15.0 TRANSIENT AND ACCIDENT ANALYSES

Figure 15.1-2. Typical ESBWR Startup Path.

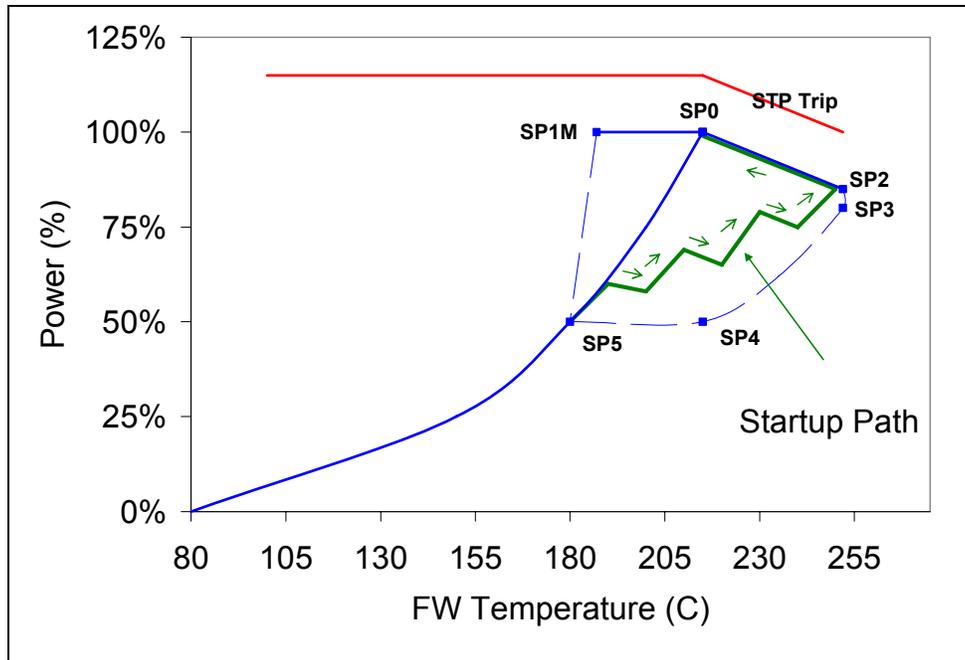
One of the primary advantages of the FWTOD is realized during reactor startup. Figure 15.1-2 in this report shows a typical startup path for the ESBWR. Up to point SP5, the operator simply pulls control blades with feedwater heaters Nos. 1 through 6 fully open and feedwater heater No. 7 closed, because rod heatup is not a concern when the power level is below 50 percent. As the power increases, the turbine control valve (TCV) opens to provide higher steam flow to the turbine to maintain constant reactor pressure.

Figure 15.1-3. ESBWR Operating Domain Showing Protection and Control Functions.

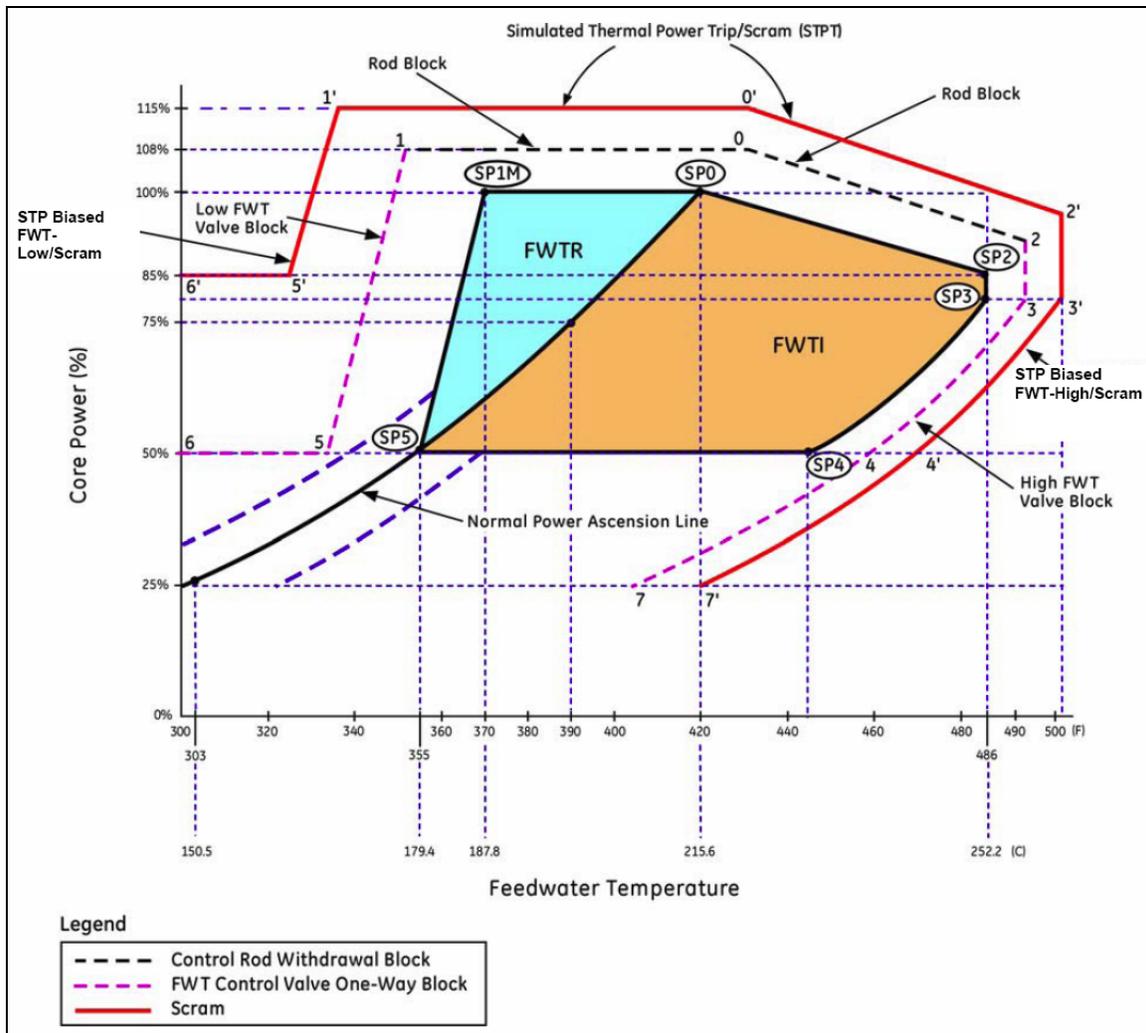
optimized for efficiency. The FWTR region in Figure 15.1-3 (i.e., point SP2) is expected to be used during startup and rod pattern exchanges. The FWTR region in Figure 15.1-3 (i.e., the line between SP0 and SP1M) may be used for fine reactivity control or for reactivity stretching towards end of cycle (EOC). In RAI 4.3-25, the staff requested that the applicant discuss whether it is possible to use the region between SP0 and SP1M to provide an-end-of-cycle stretch. In response to the staff's RAI 4.3-25, the applicant specified that EOC stretch will not be accomplished by reducing FWT in the ESBWR. If in the future, a licensee intends to implement low-temperature EOC stretch, additional analyses will need to be performed and reviewed.

Figure 15.1-3 shows a detailed FWTOD map that defines not only the operating domain but also the protection system actuation lines, as well as the control system blocks on control rod and feedwater valve actuation. These blocks indicate the region where operation is restricted by means of the conventional control system. Unintended operation outside this region results in a control room alarm.

The applicant has provided an evaluation of the impact of varying FWT according to this map of the reactor transient response in NEDO-33338, Revision 1, for the initial core design documented in NEDO-33326, Revision 1, "GE14E for ESBWR Initial Core Design Nuclear Report," issued March 2009, and the DCD Tier 2, Revision 9, EC analysis in Chapter 15. The applicant has compared the results against the nominal operating point (SP0) reported in ESBWR DCD Chapter 15 for an EC and in NEDO-33337 for the ICL. All analyses have been performed using the approved version of the TRACG code.

The results of the analyses indicate that the most limiting AOO is the IICI at SP2 state point for both equilibrium and initial cores. The most limiting IE is the generator load rejection with total bypass failure at SP1 for the EC and at SP0 for the initial core. However, the largest change in the CPR when the FWT is changed occurs for the LOFWH event, and therefore, it may have a larger impact on the operating limit MCPR at points SP1M and SP2.
